**ADDENDUM No. 1**  
**FOR**  
**HURON PARK, JACK DARLING COMFORT STATIONS**  
**830 PAISLEY BOULEVARD WEST & 1180 LAKESHORE ROAD WEST**  
**&**  
**JACK DARLING EAST COMFORT STATION**  
**1180 LAKESHORE ROAD WEST**  
**PROCUREMENT NO. PRC005197**

**PROJECT No: 24-053 & 25-059**

**DATE: NOVEMBER 6, 2025**

**3 REFLECTED CEILING PLAN**  
SCALE 1:50

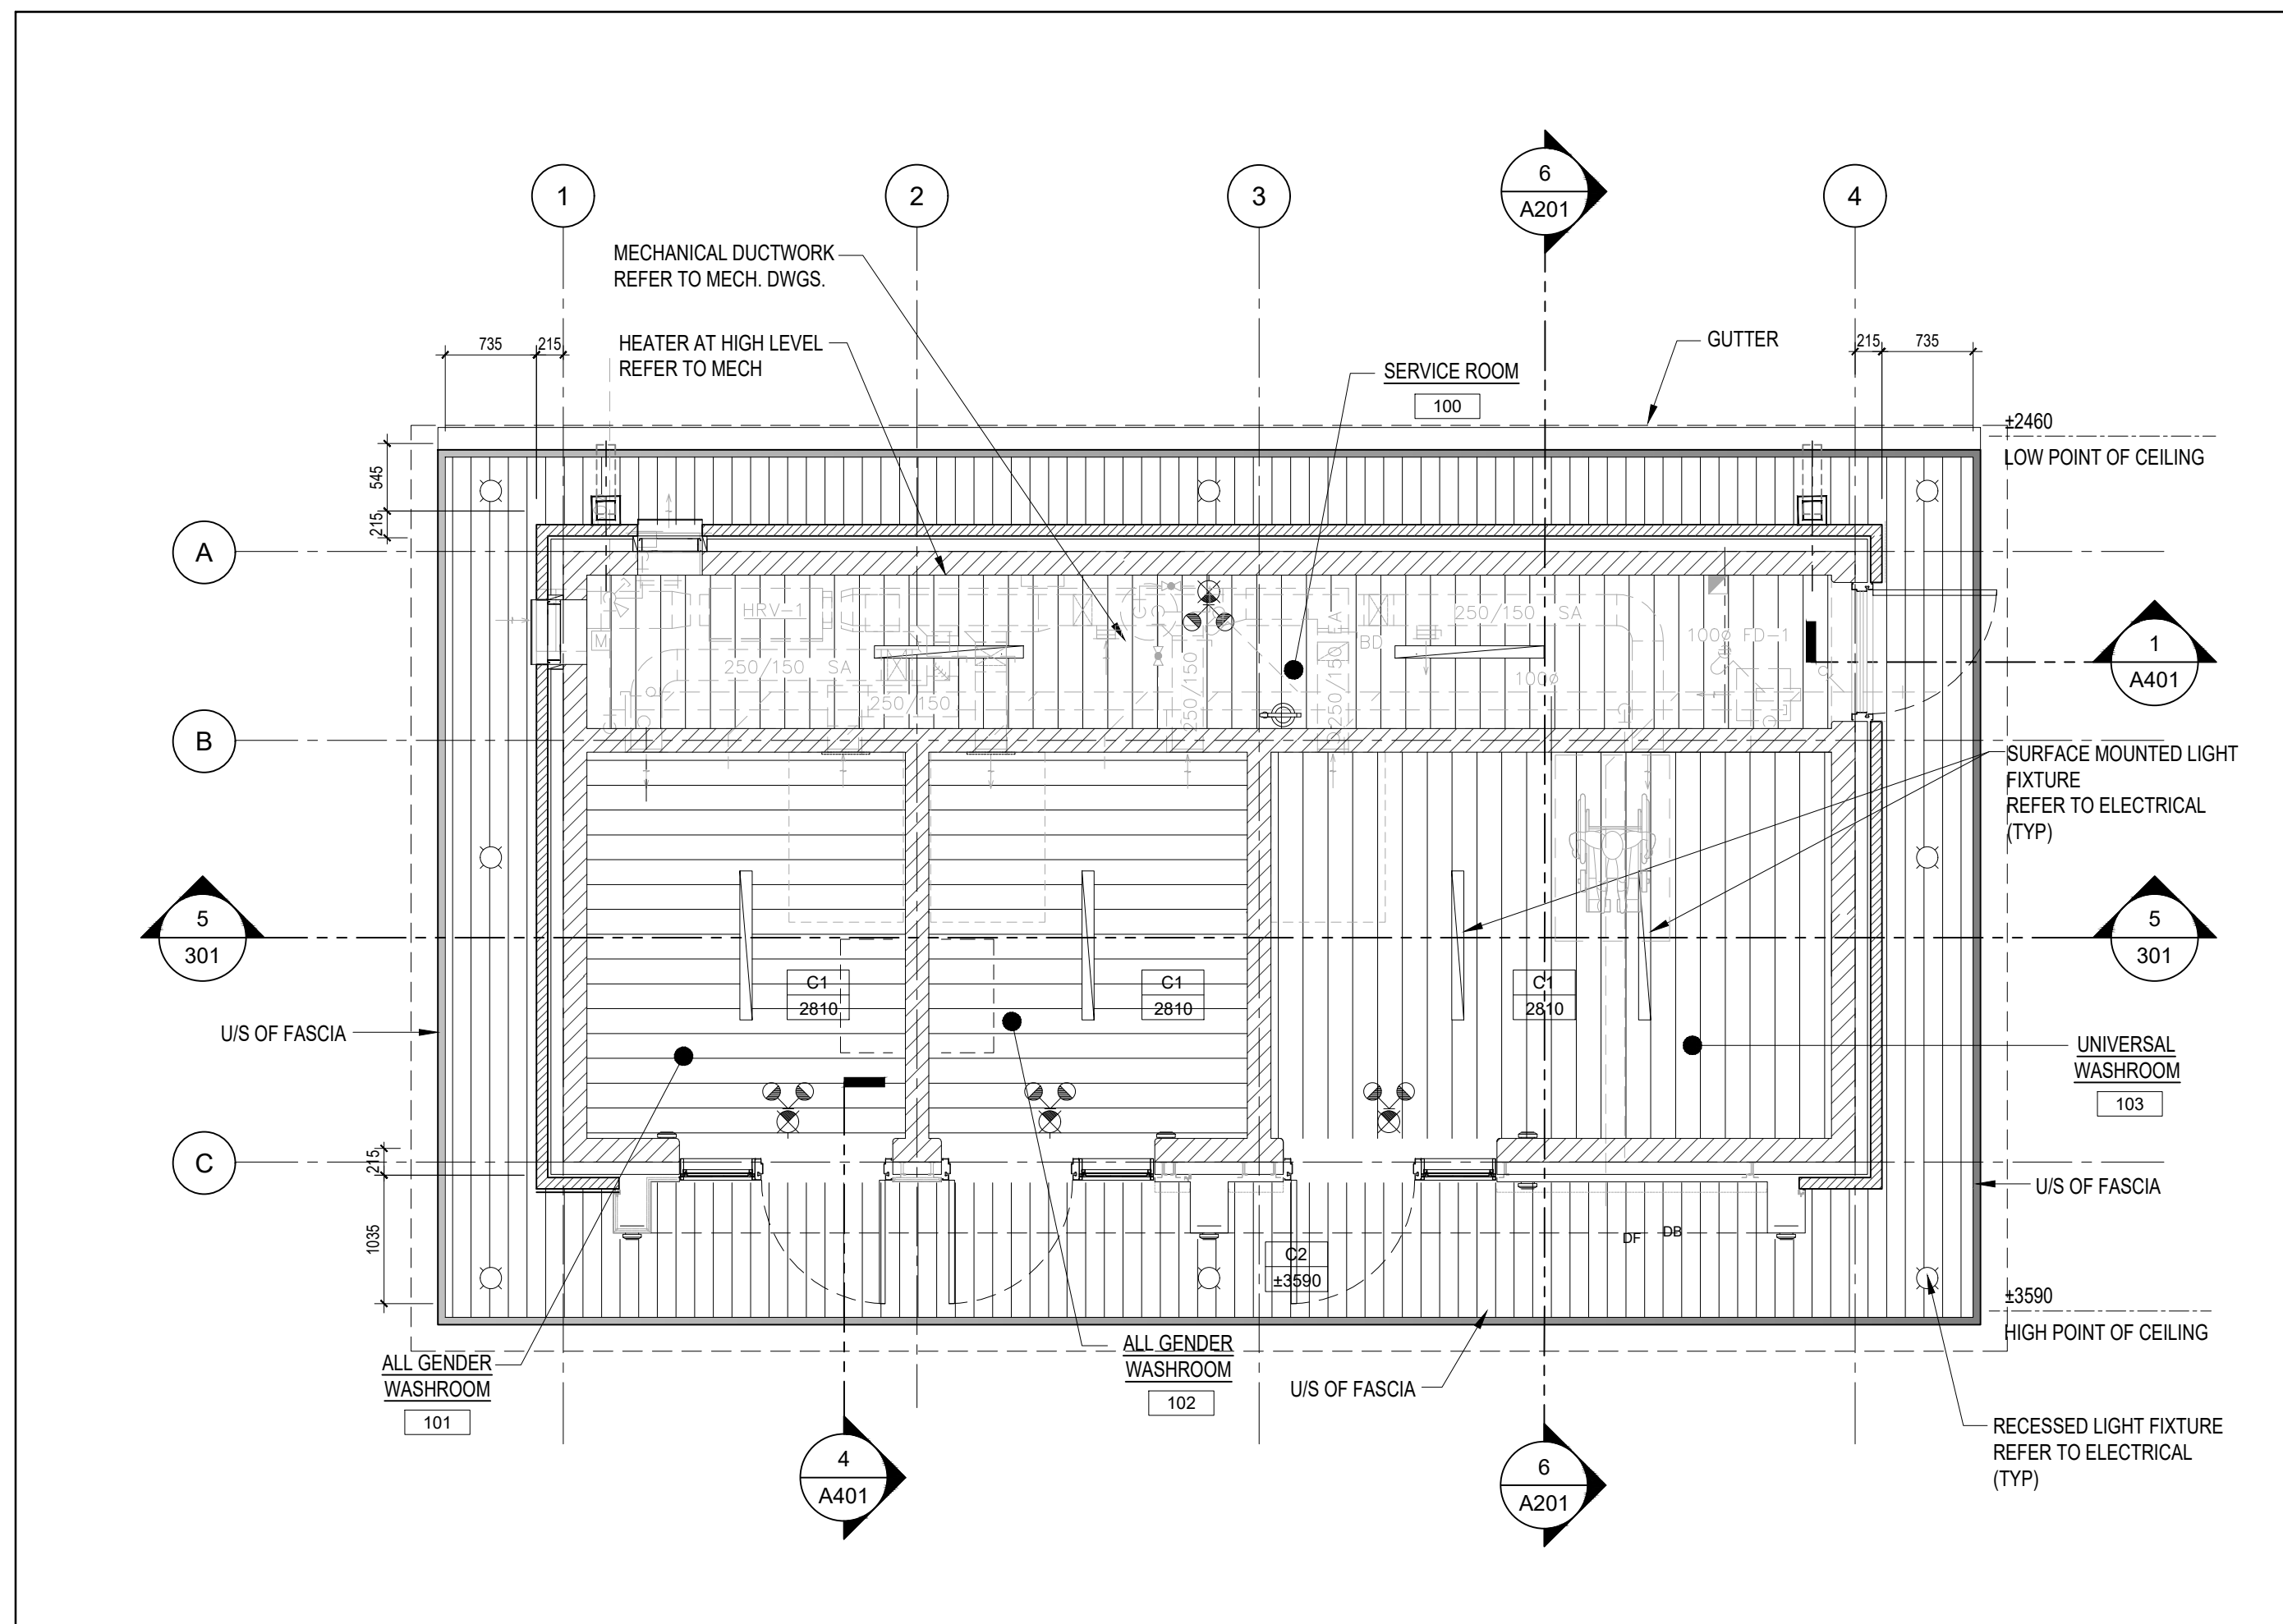
- 1.1. A-002 Revisions – Revisions to Door Frames/Screens.
- 1.2. A101 Revisions – Exterior Elevations Hose Bib locations indicated
- 1.3. A201 Revisions – Grilles and Door Frames/Screens.
- 1.4. A301 Revisions - Door Frames/Screens.
- 1.5. A401 Revisions - Louvres and lintels

**Site Servicing Drawing, SS-1**

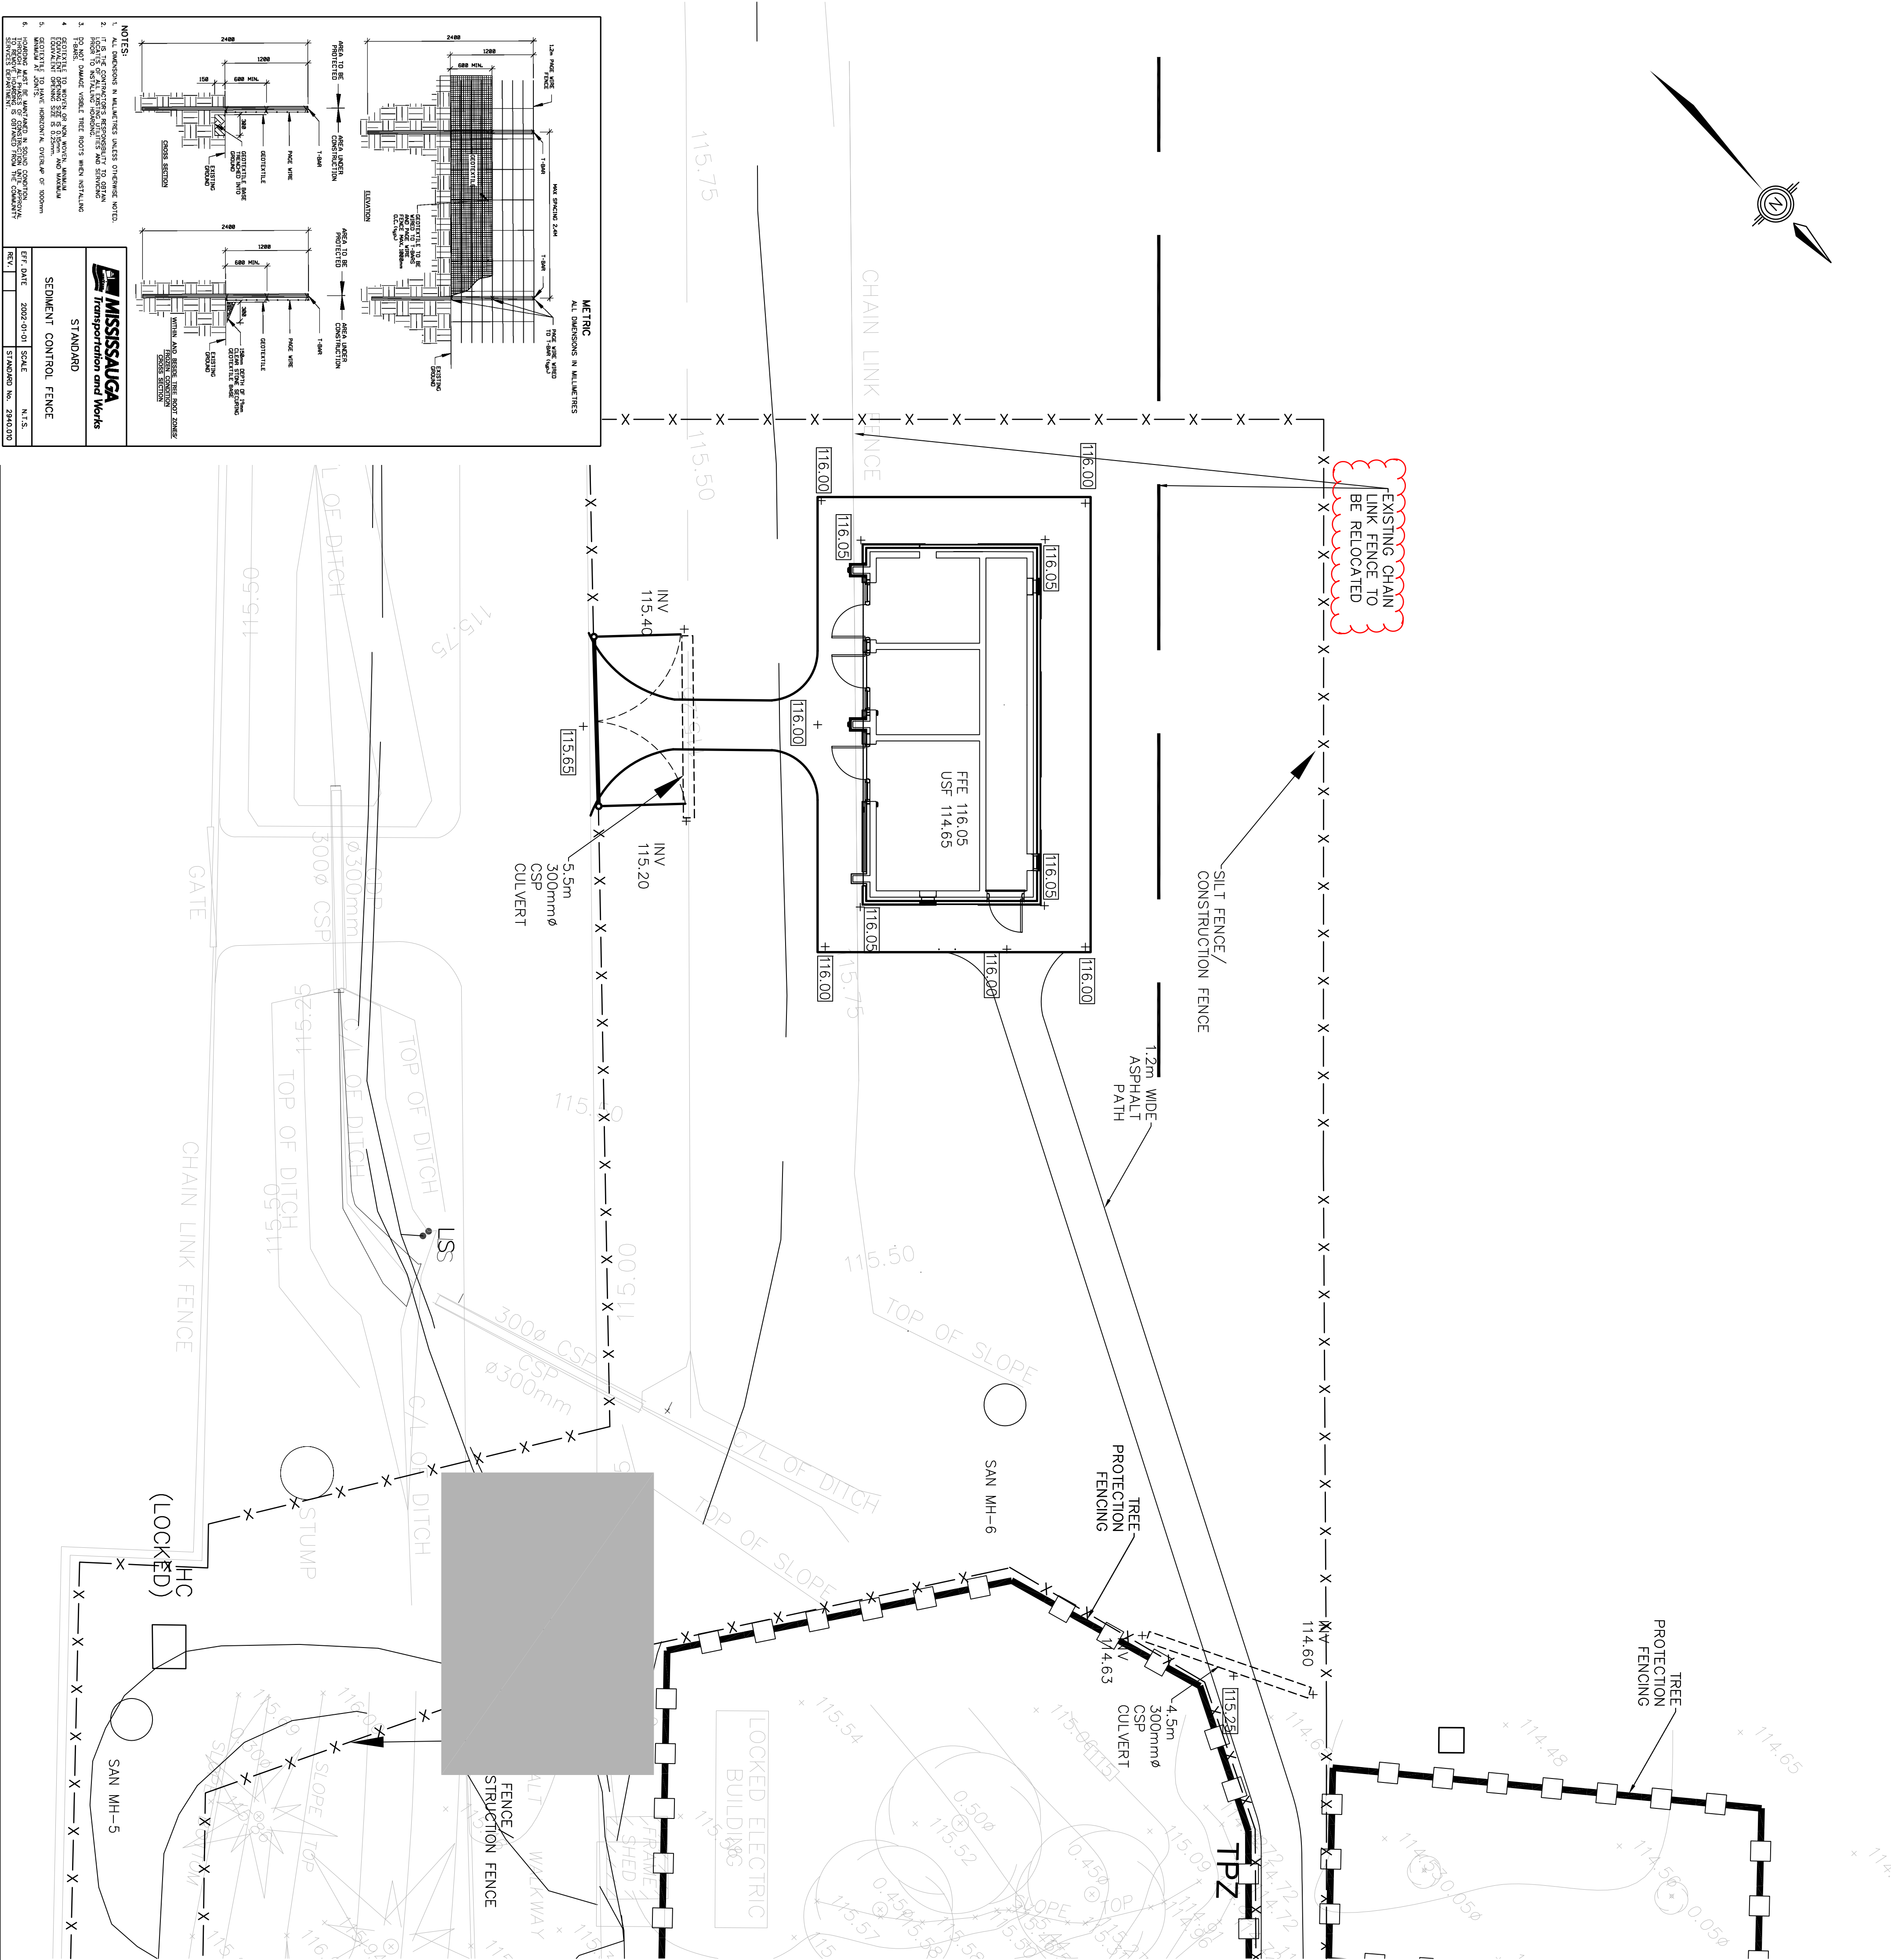
1. Water meter and backflow added in the building as shown on the attached Servicing Drawing SS-1.

L-SP

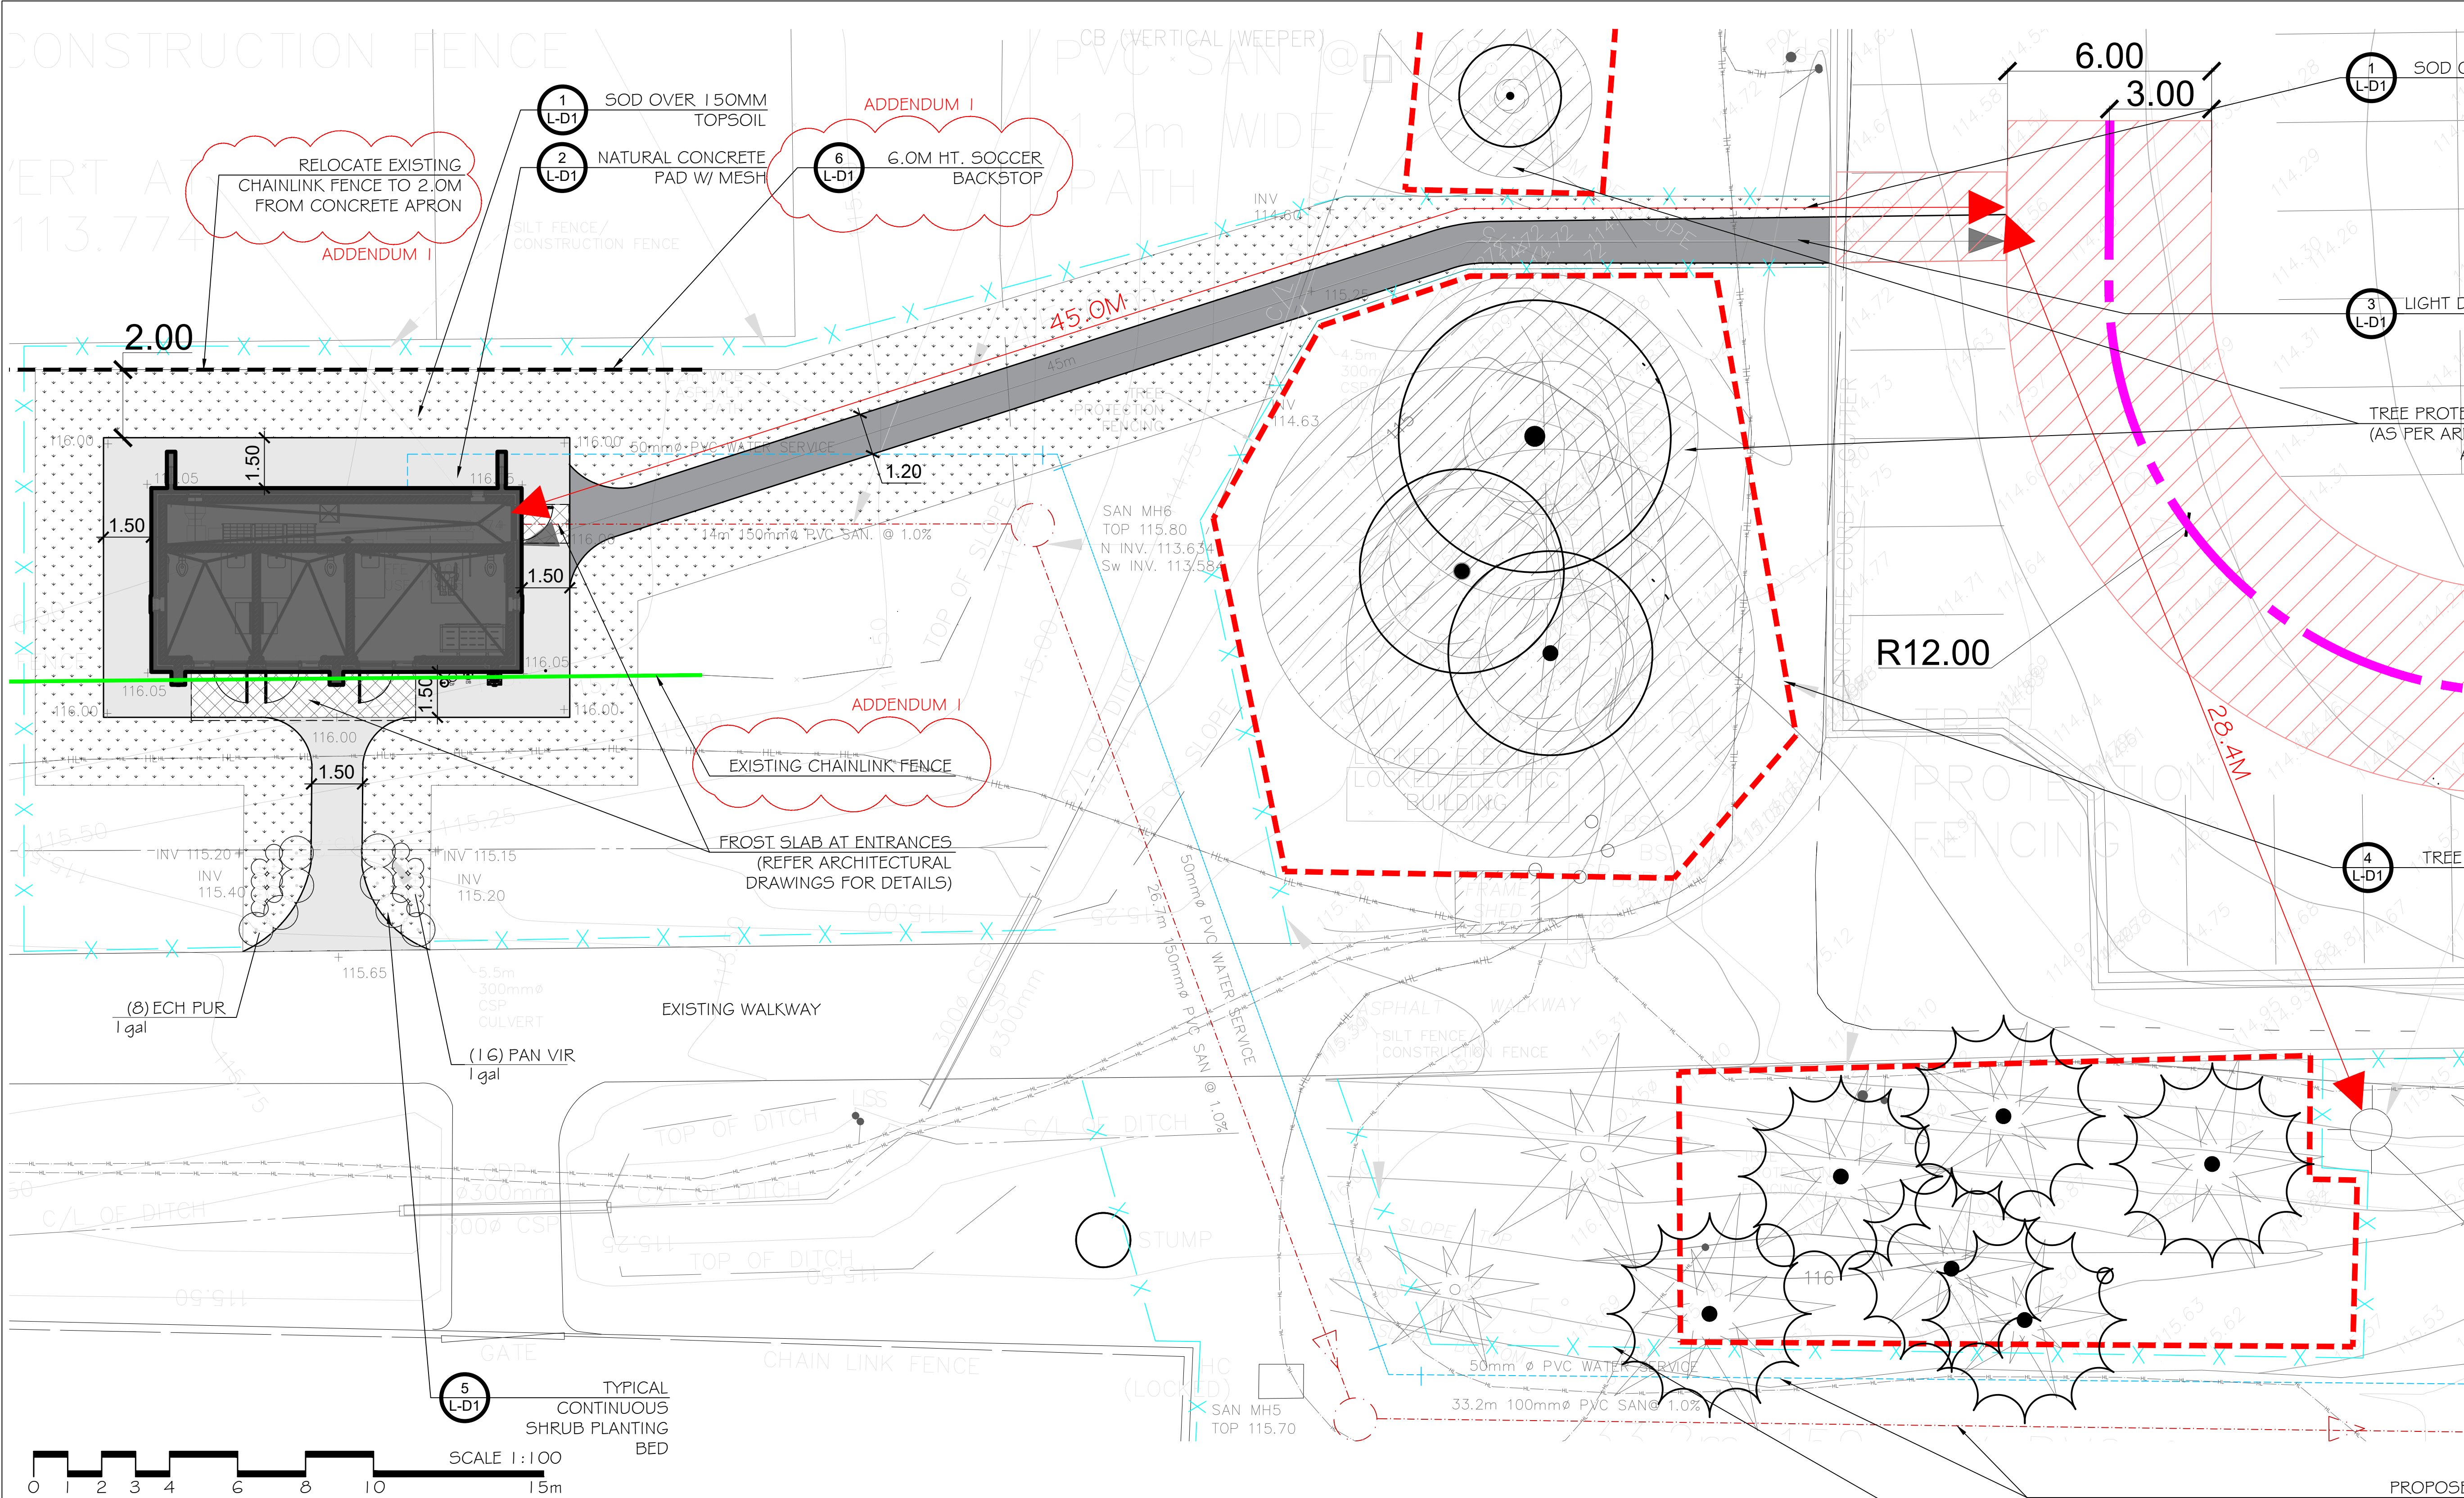
1. The existing chain link fence is to be relocated to the location shown on the attached drawings. The contractor shall ensure that the fence is installed at a 2 m offset from the proposed concrete apron, as indicated on drawings L-SP and L-L1.
2. A chain link fence detail has been added to sheet L-D1. Refer to Detail 6/L-D1.
3. The specification for the chain link fence has been included in this addendum.
4. The contractor shall verify and confirm that no underground utilities are present at the proposed fence relocation area prior to commencing construction.
